STATE OF HAWAII
DEPARTMENT OF TRANSPORTATION
HIGHWAYS DIVISION
UTILITY PLAN
MAUNA KEA MAINTENANCE
BASEYARD
DANIEL K. INOUE HIGHWAY
Project No. 200A-01-10
Scale: As Shown Date: April, 2018

1	06-07-18	ADDENDUM NO. 4	
REVISION	DATE	DESCRIPTION	AA15

STATE OF HAWAII
DEPARTMENT OF TRANSPORTATION
HIGHWAYS DIVISION
SHOP BUILDING
MAUNA KEA MAINTENANCE BASEYARD
DANIEL K. INOUE HIGHWAY
Project No. 200A-01-10

AD12

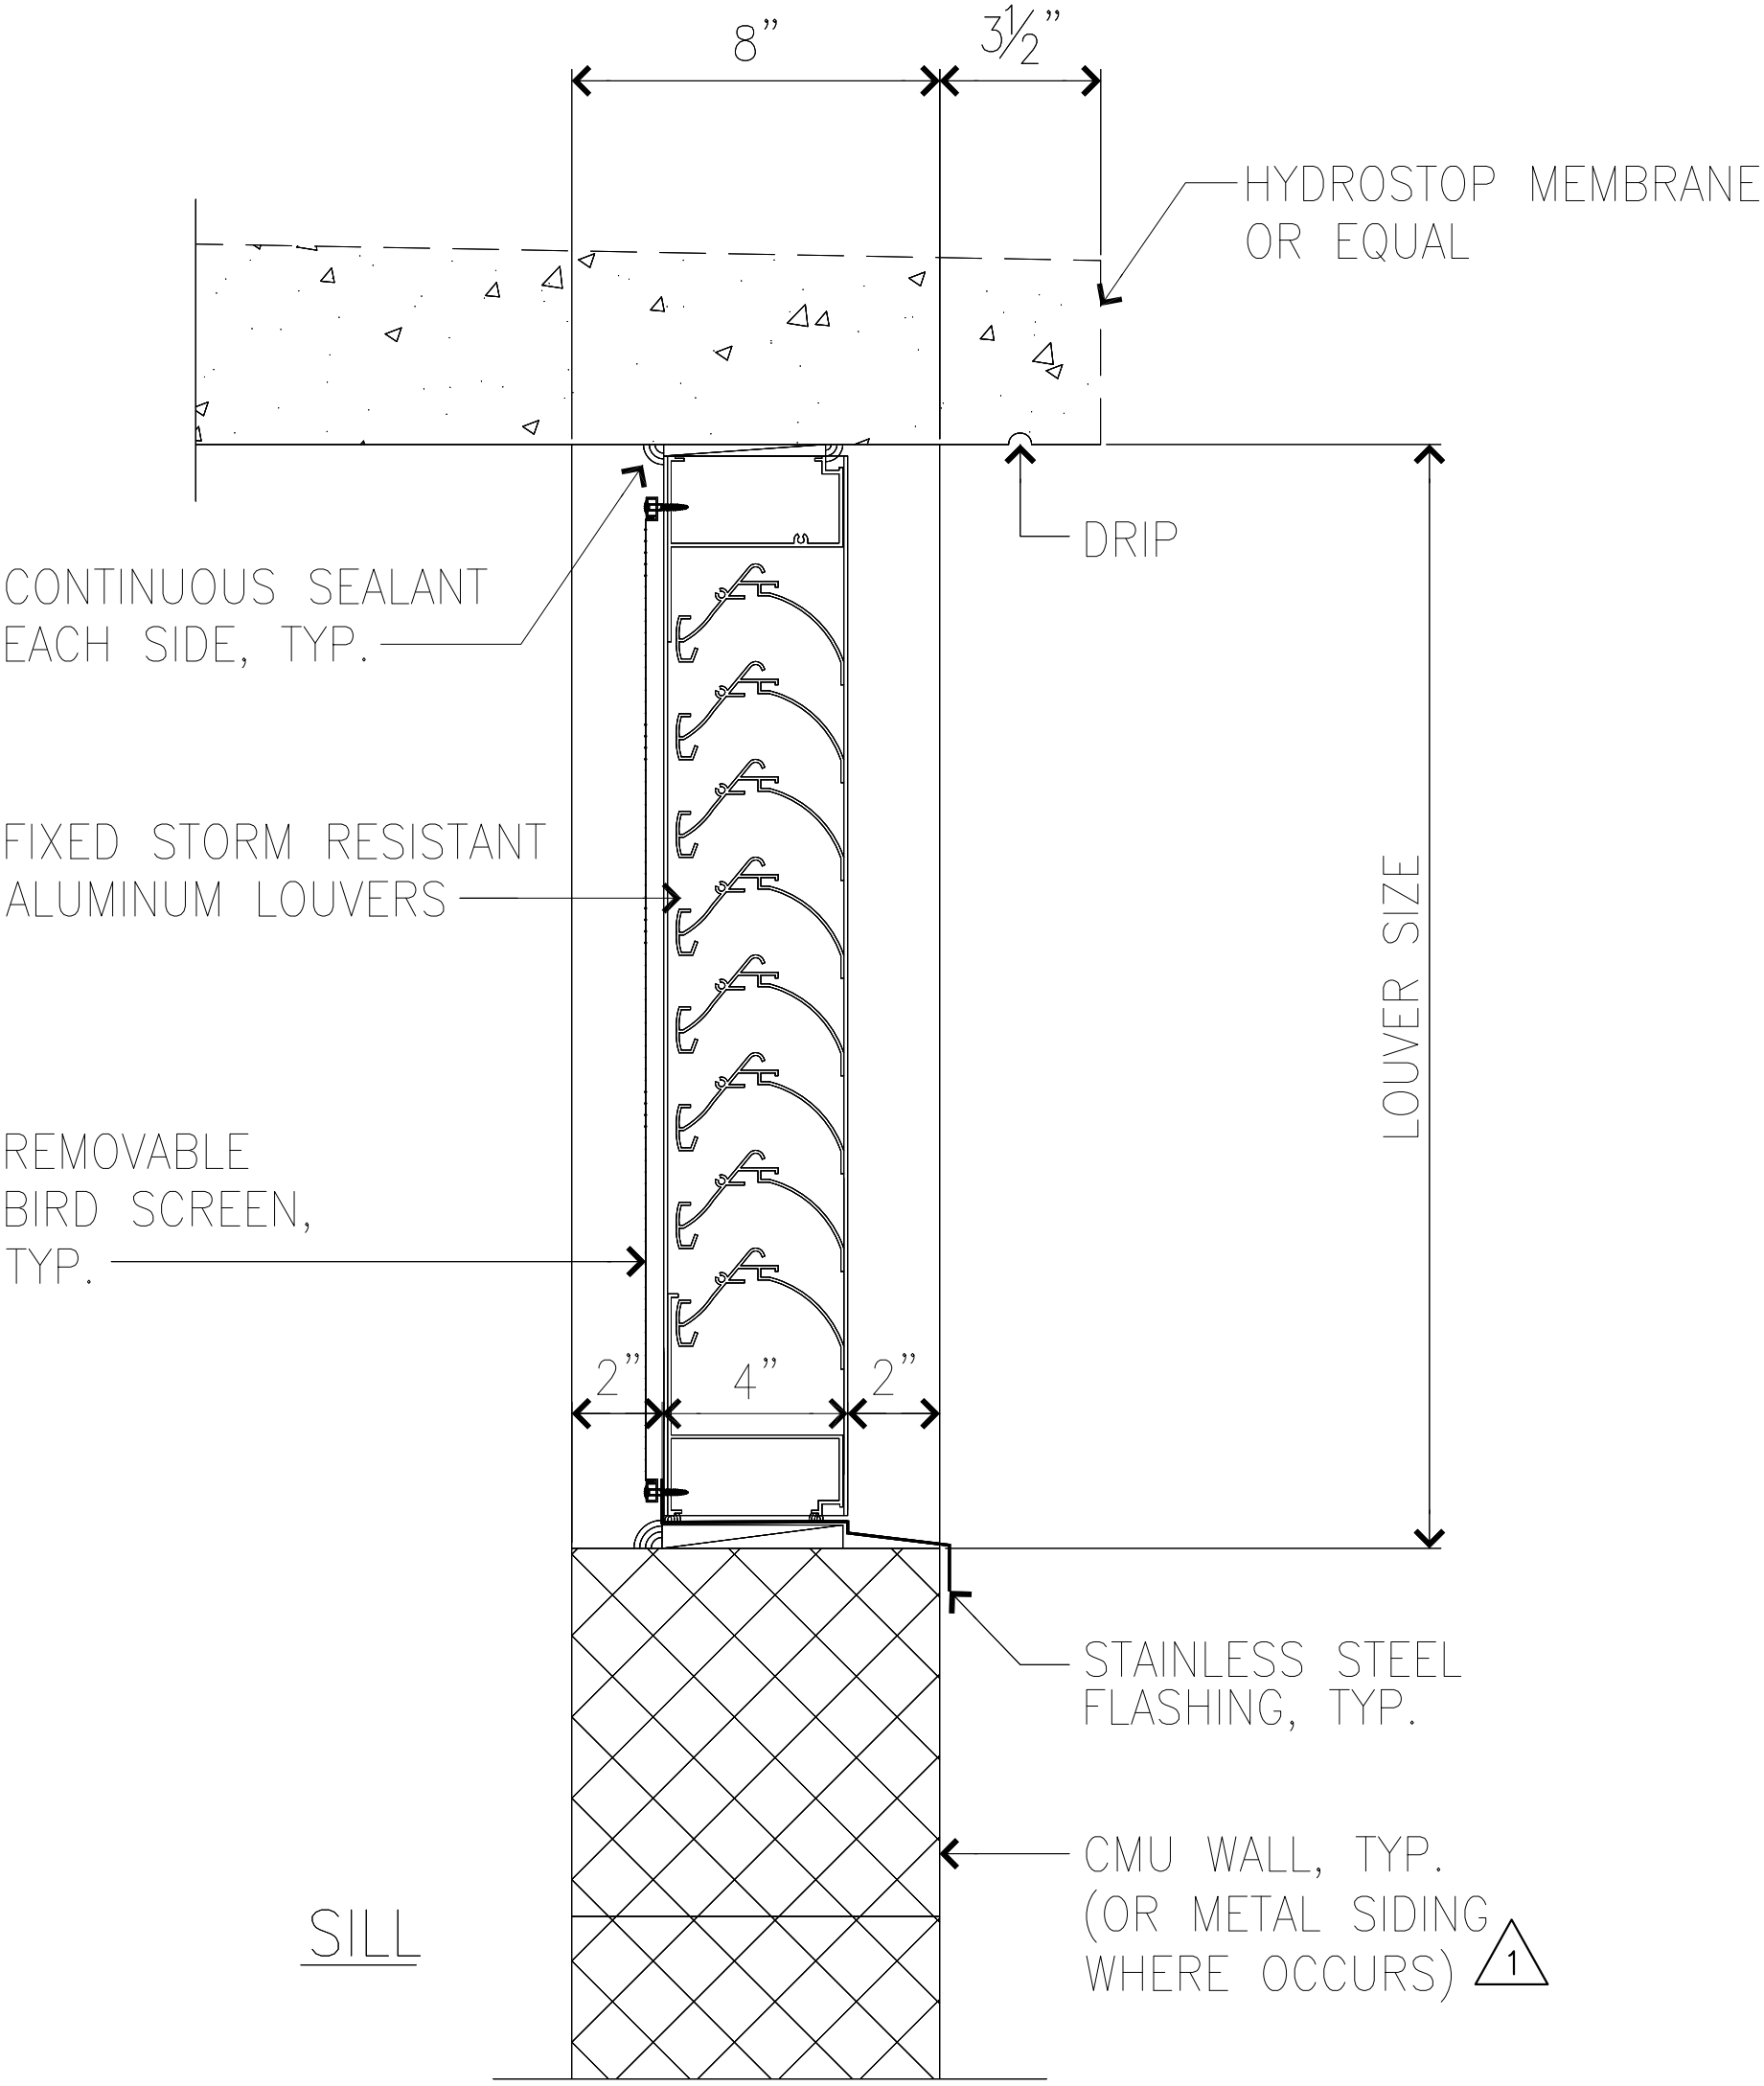
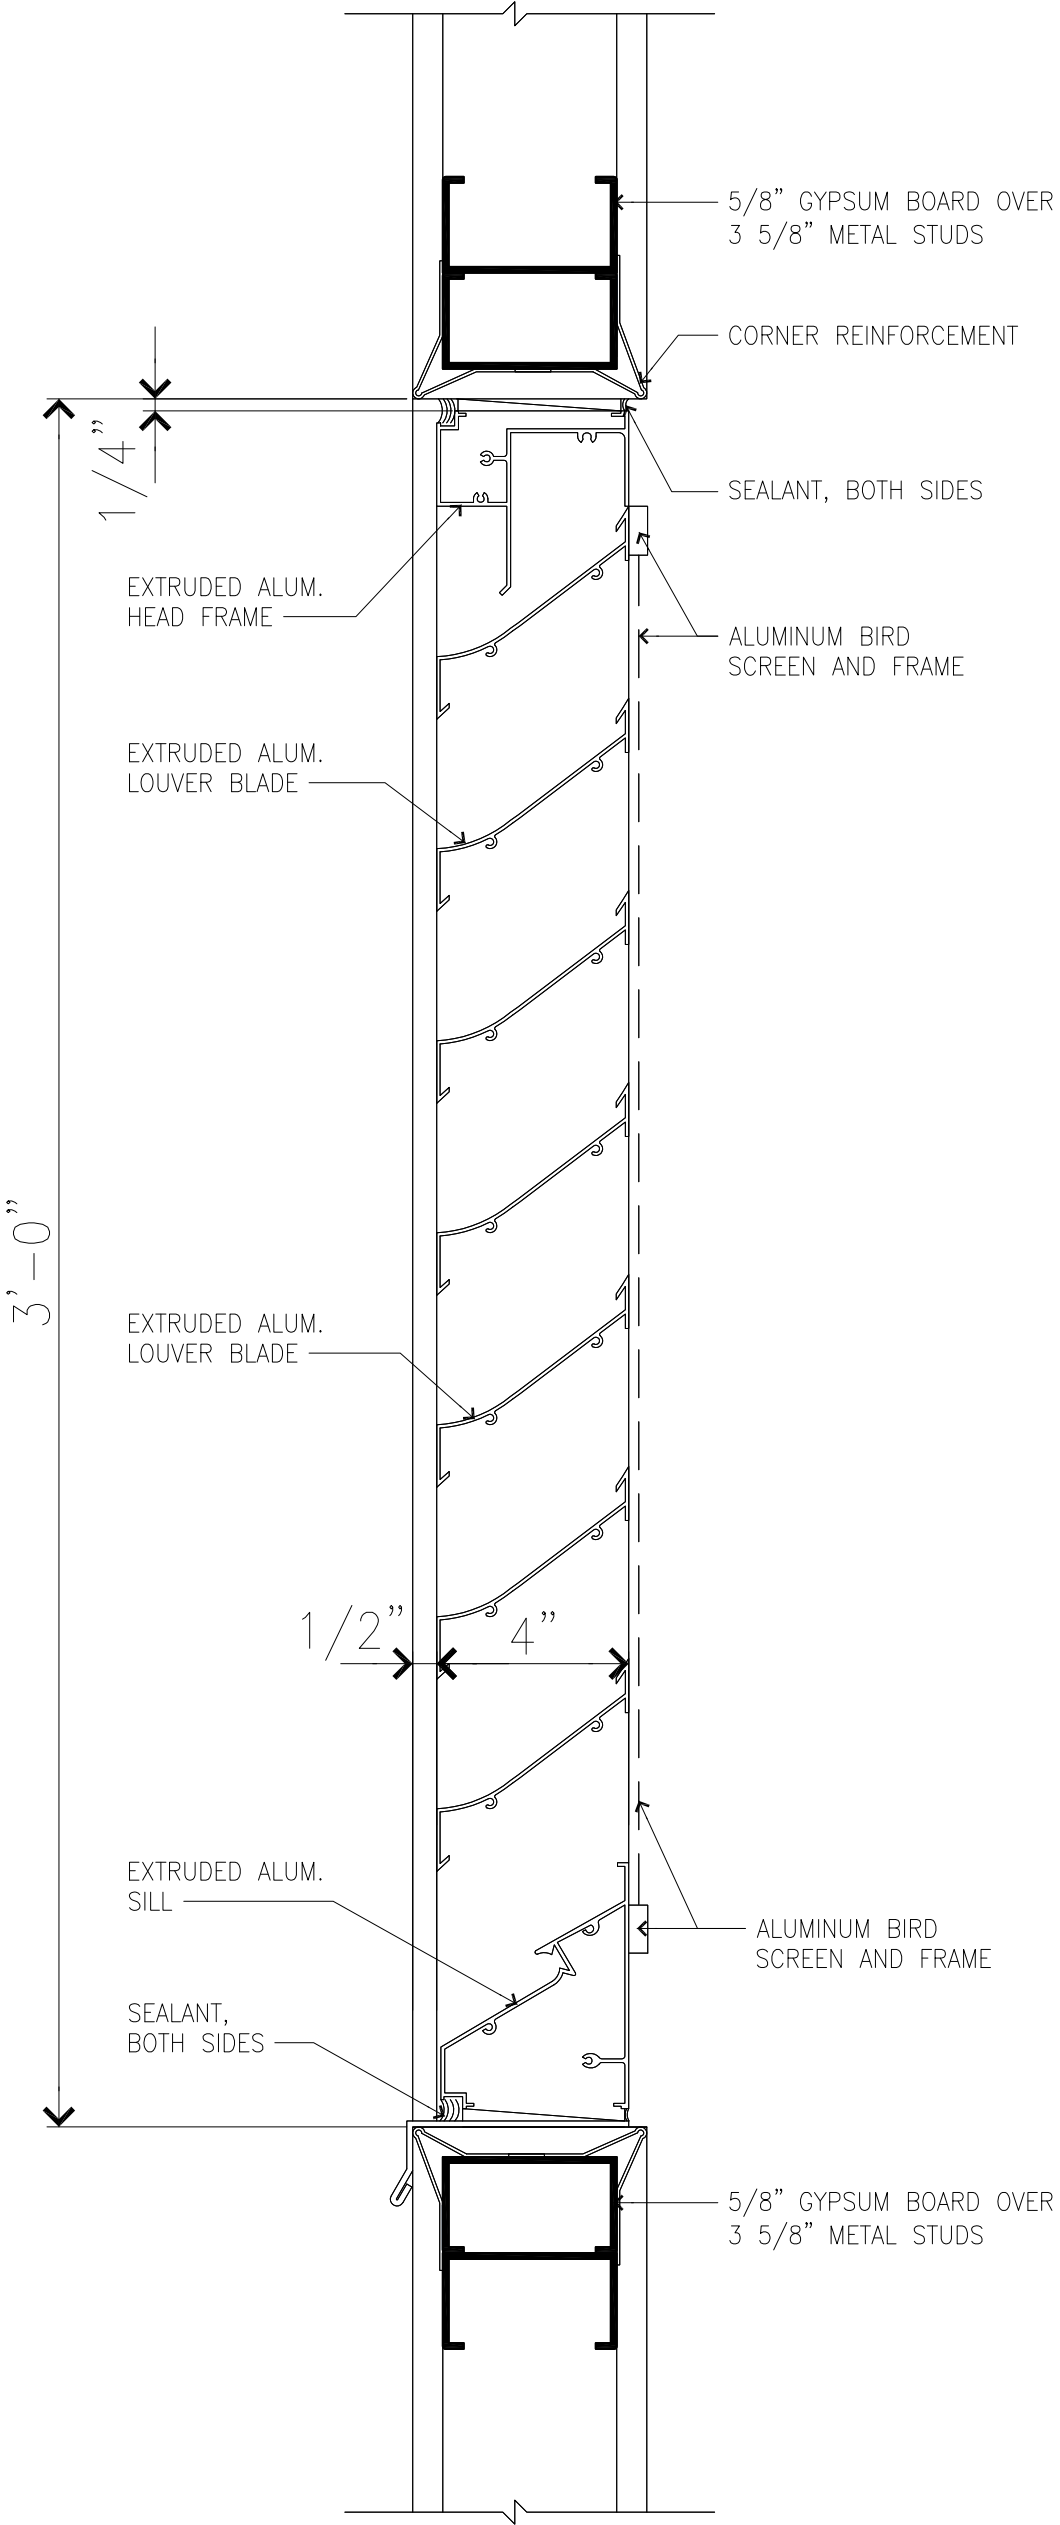
06-07-18	1 LOUVER DETAIL REVISION
DATE	REVISION
STATE OF HAWAII DEPARTMENT OF TRANSPORTATION HIGHWAYS DIVISION DETAILS MAUNA KEA MAINTENANCE BASEYARD DANIEL K. INOUE HIGHWAY Project No. 200A-01-10 Scale: As noted Date: April 2018 SHEET No. AD1.2 OF 46 SHEETS

- A. FIXED STORM RESISTANT LOUVER SHALL BE 5-INCH DEEP STORM RESISTANT HORIZONTAL LOUVER. MATERIAL SHALL BE OF CLEAR ANODIZED ALUMINUM WITH HEAD, SILL AND JAMB OF 0.081" THICKNESS AND BLADES SHALL BE 0.060" THICK. LOUVER SHALL BE CONSTRUCTION SPECIALTIES MODEL RS-5300 OR EQUAL.
- B. BIRD SCREEN ON INTERIOR FACE SHALL BE OF 1/2" SQUARE MESH 0.063" THICK ALUMINUM AND NON-REWIREALBLE U-SHAPED ALUMINUM FRAME.
- C. COMPLY WITH MANUFACTURER'S INSTRUCTION AND RECOMMENDATION FOR INSTALLATION OF WORK.

MA1.1

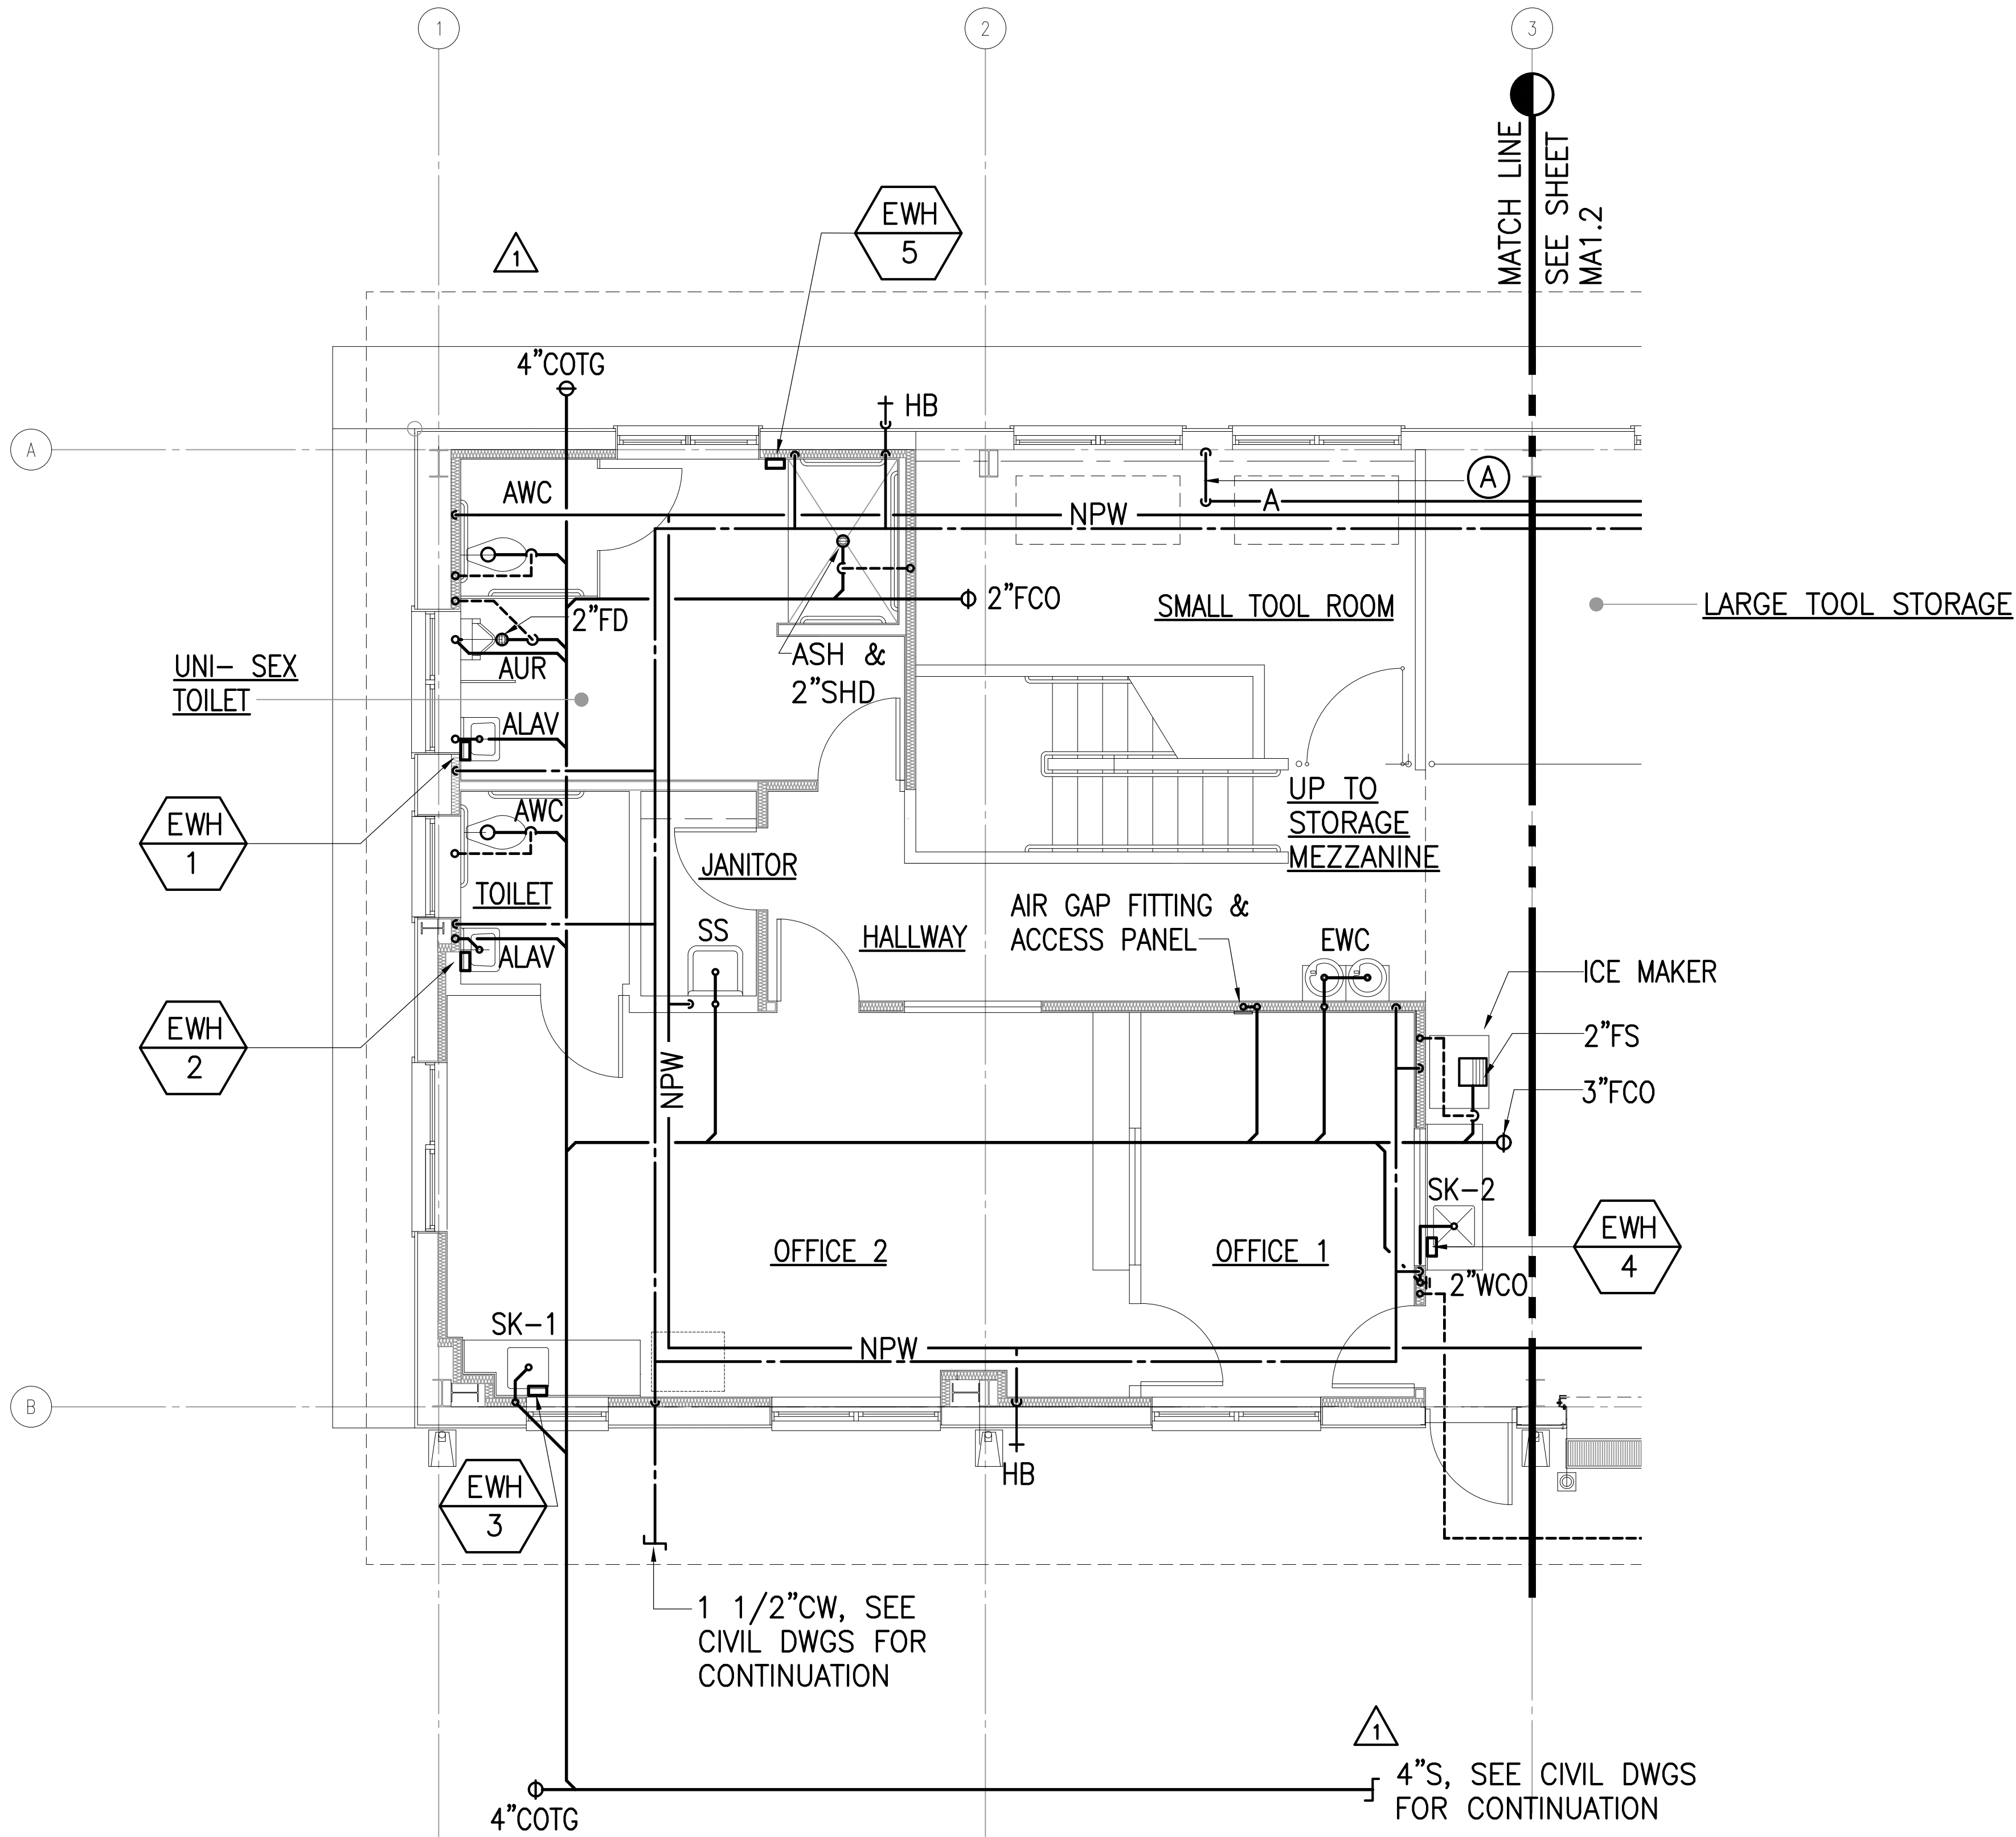
06-07-18	1	REVISED S AND NPW PIPING LAYOUT
DATE	REVISION	
STATE OF HAWAII DEPARTMENT OF TRANSPORTATION HIGHWAYS DIVISION		
<u>SHOP BLDG PLUMBING</u>		
<u>MAUNA KEA MAINTENANCE</u>		
<u>BASEYARD</u>		
<u>DANIEL K. INOUE HIGHWAY</u>		
<u>Project No. 200A-01-10</u>		
Scale: As Noted		Date: April 2018
SHEET No. MA1.1 OF 19 SHEETS
